Design Review Committee Meeting

DEPARTMENT OF PLANNING AND ZONING
PLANNER'S REPORT

DATE: July 15, 2021
TO: Tonya Hutson
FROM: Lynn Patterson
RE: **Design Review – 3227 Jackson St**

PROPOSED
SITE PLAN

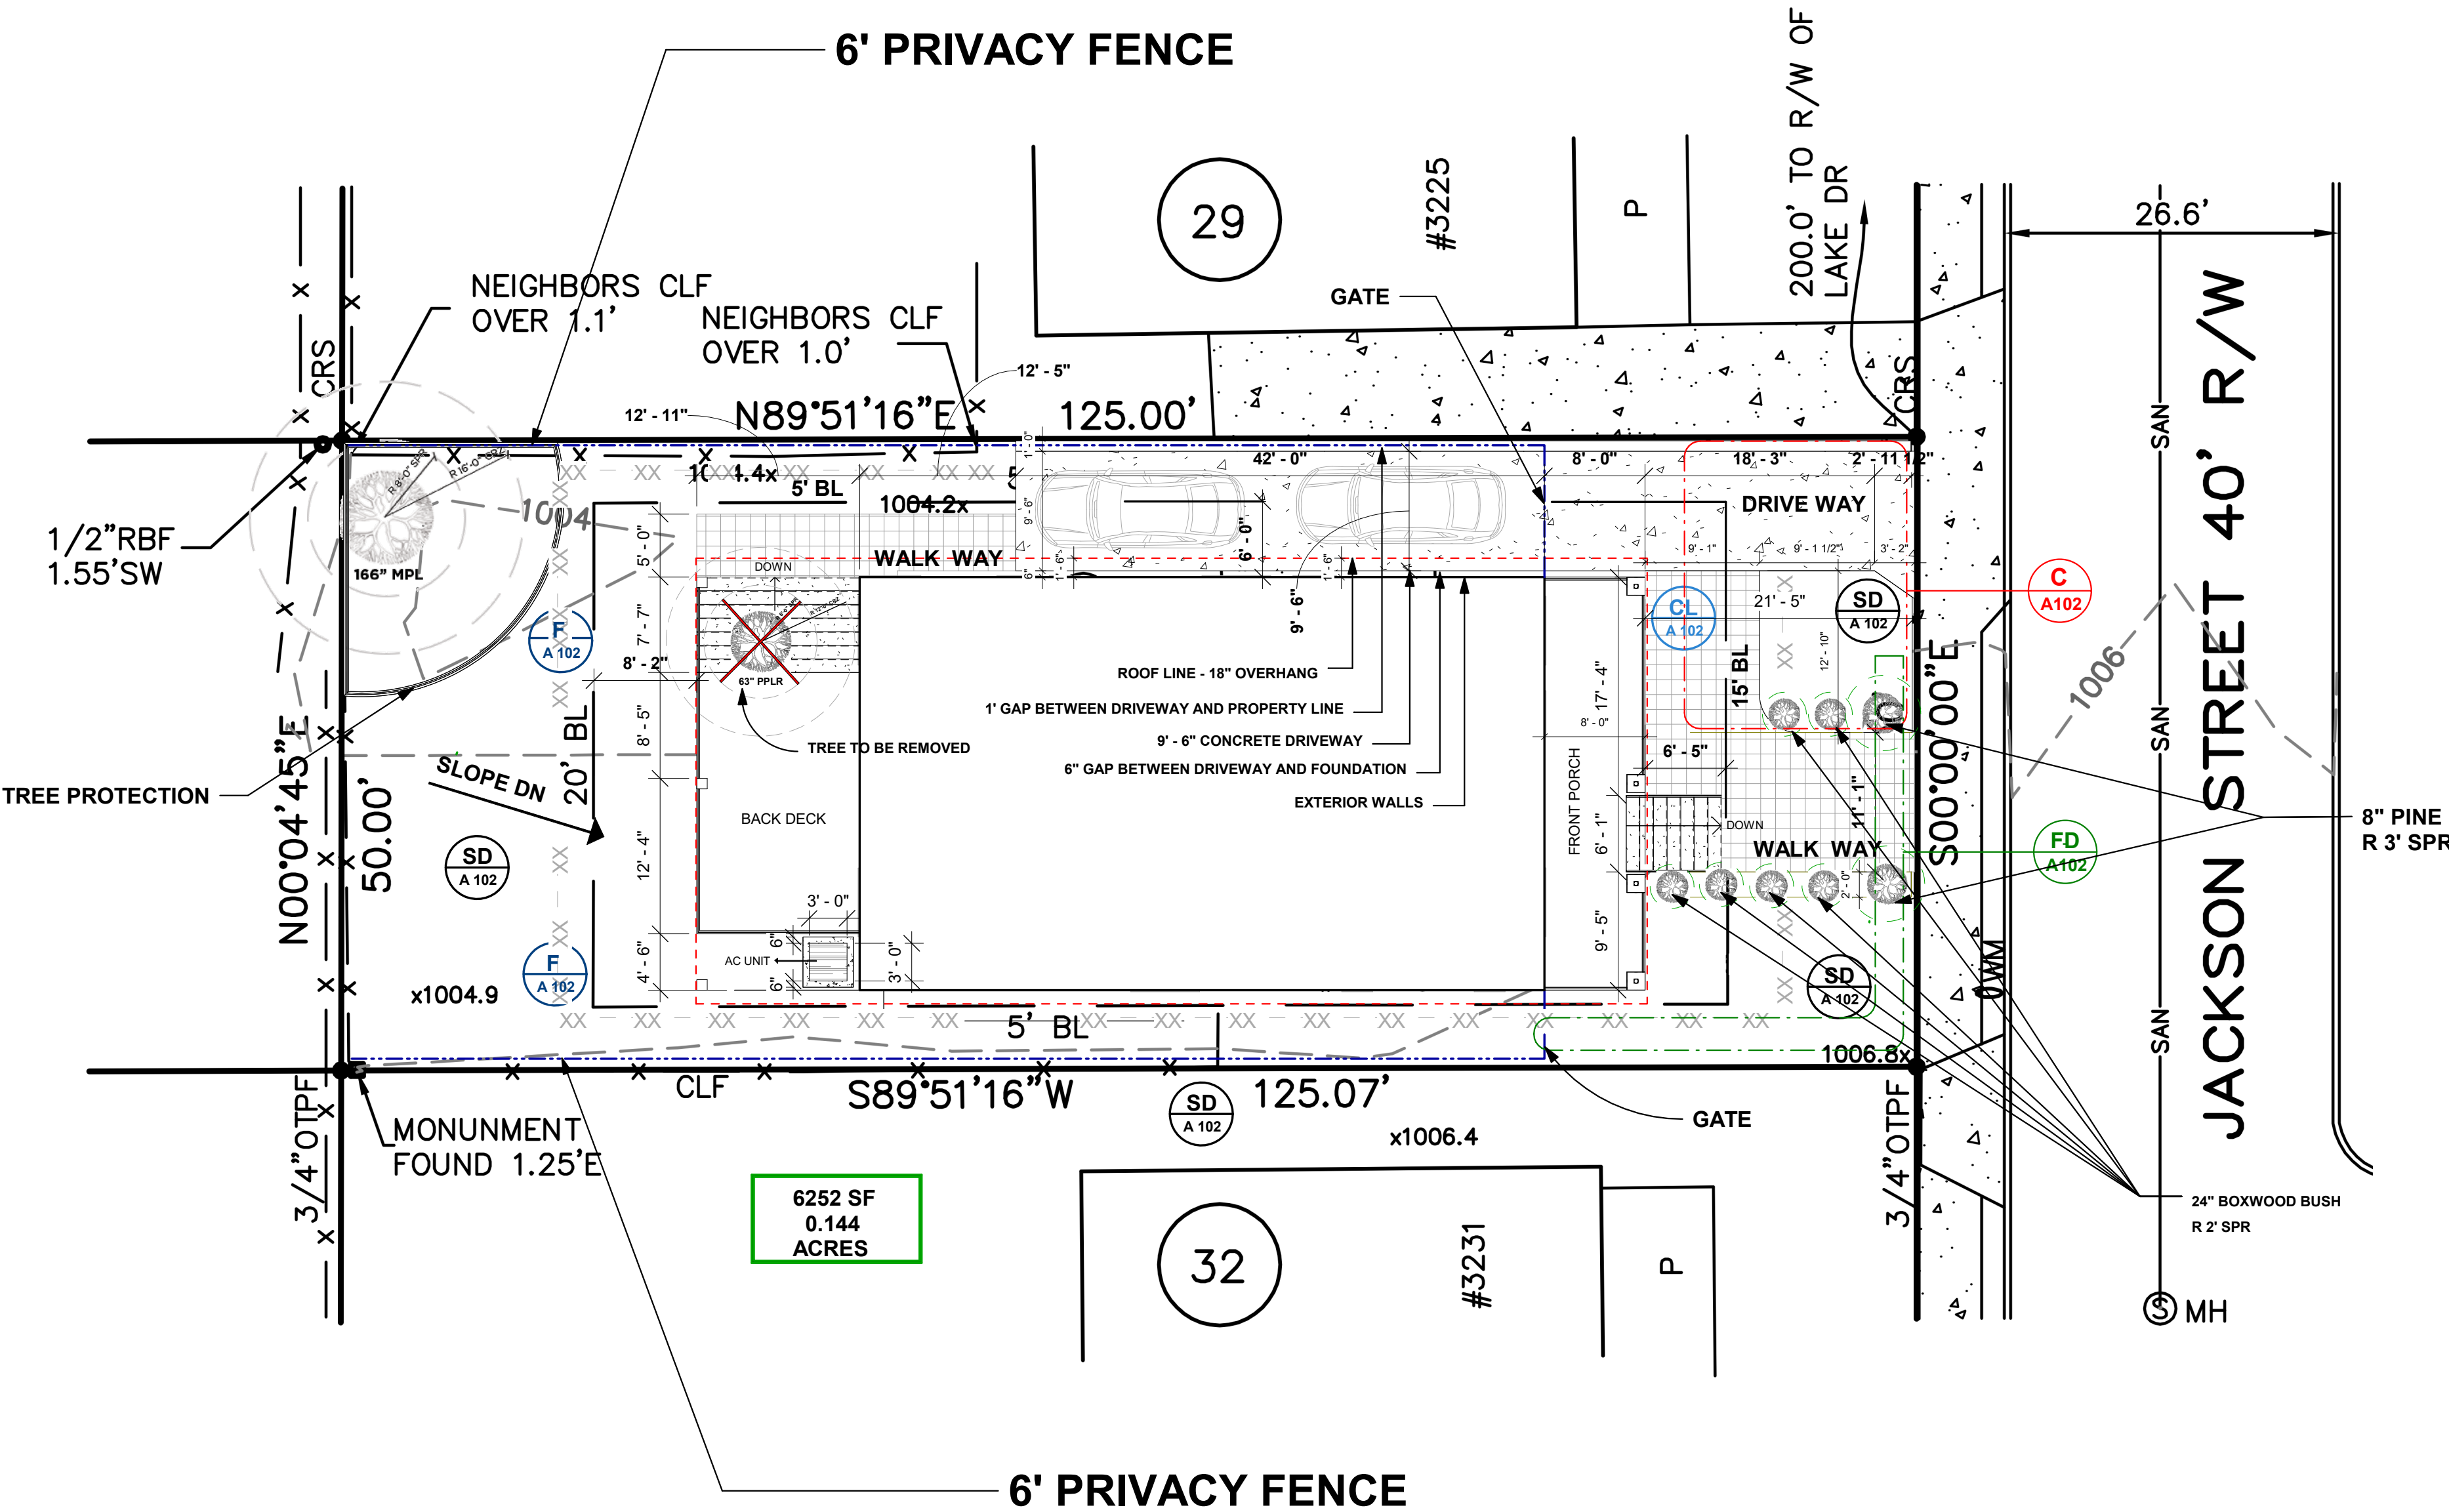
STAFF COMMENT: Tree Conservation Plan to be finalized with Arborist. Gate should be wooden and not chain link – not specified on plans.

STAFF COMMENT: Parking is shown along the side of the house beyond the front façade, however, the width of the driveway is 9'6" which may not be adequate to accommodate cars, particularly with the proposed fencing. Applicant should advise.

- Tree Conservation Plan to be finalized with Arborist.
- Gate should be wooden and not chain link – not specified on plans.
- Parking is shown along the side of the house beyond the front façade, however, the width of the driveway is 9'6" which may not be adequate to accommodate cars, particularly with the proposed fencing. Applicant should advise.

① EAST ELEVATION.
3/8" = 1'-0"

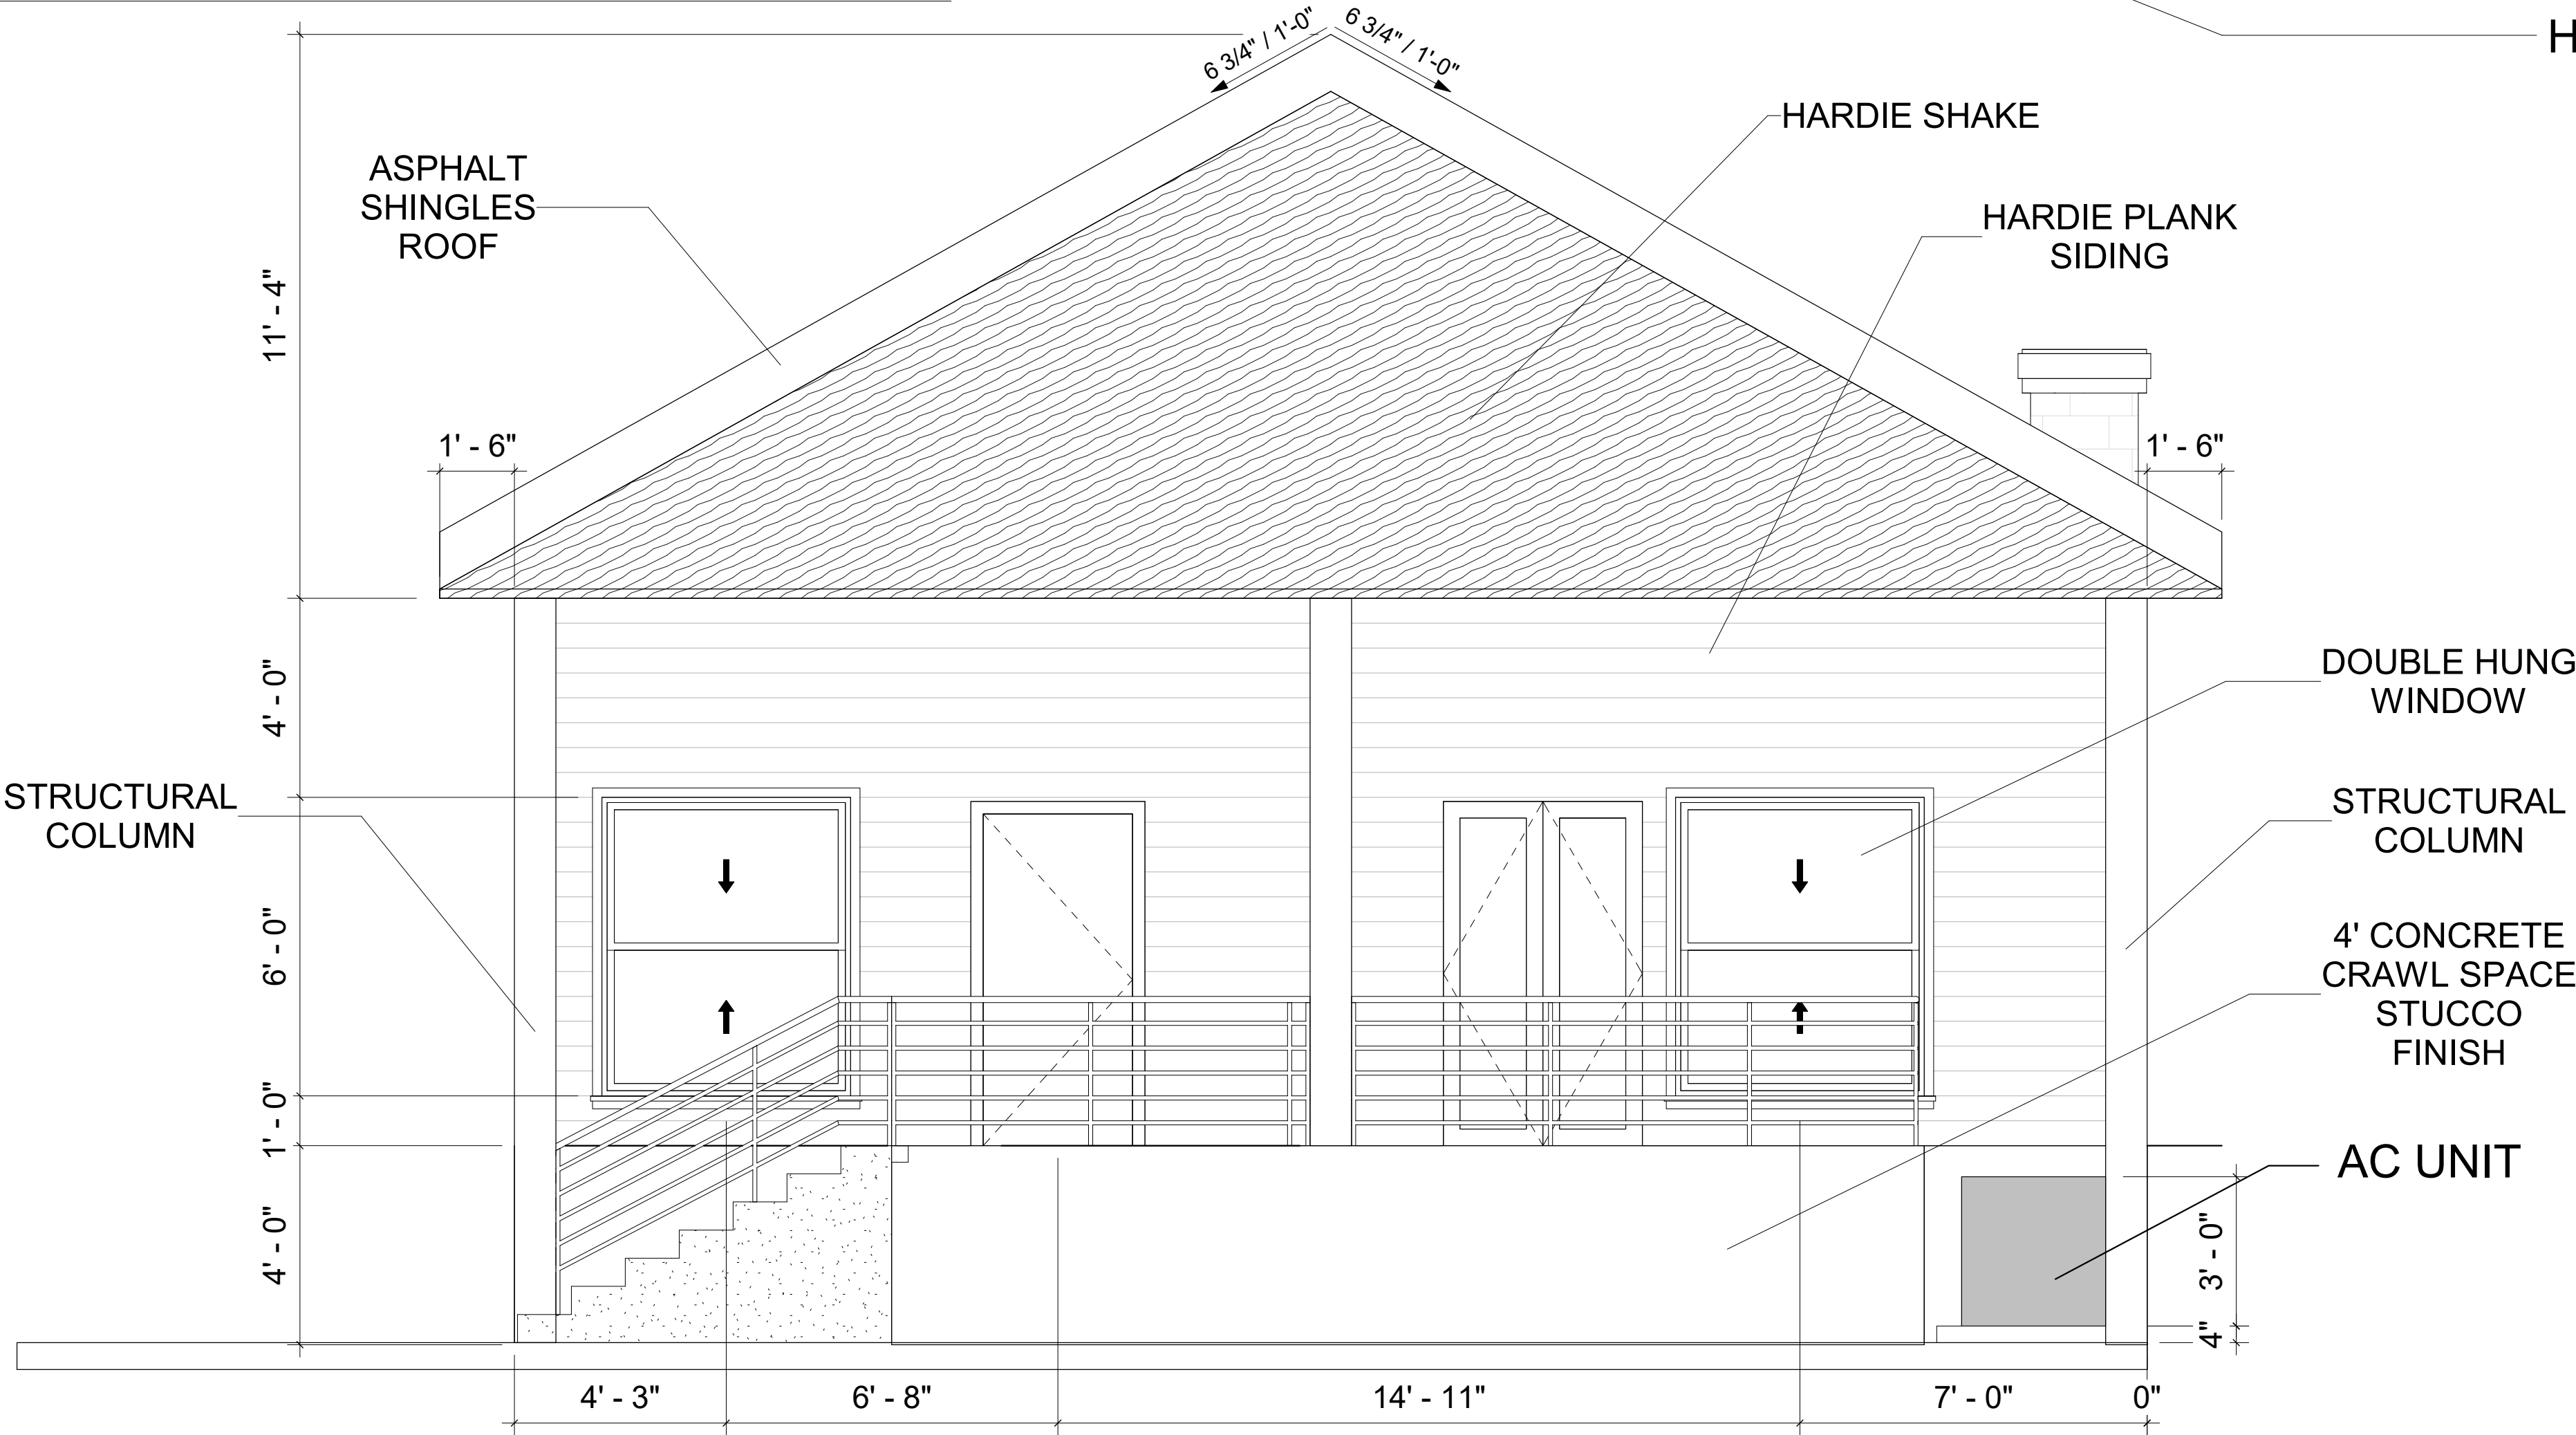
STAFF COMMENT: Chimney appears to vent through roof. Chimneys exposed to the public view may not be faced in wood or cement based siding and may not be of an exposed metal or ceramic pipe. All chimneys shall be wrapped in a brick, stone or suitable masonry finish material.

STAFF COMMENT: All porches must be painted or stained. Column piers should extend to grade. Columns are more than 8' on center. Railings do not meet standard.

STAFF COMMENT: *Sill height appears to be 1' instead of required 2.5'*

- All porches must be painted or stained.
- Column piers should extend to grade.
- Columns are more than 8' on center.
- Railings do not meet standard.
- Provide trim detail to demonstrate it meets standards

- Address sill height
- Approved Tree Conservation Plan (finalize with Arborist)
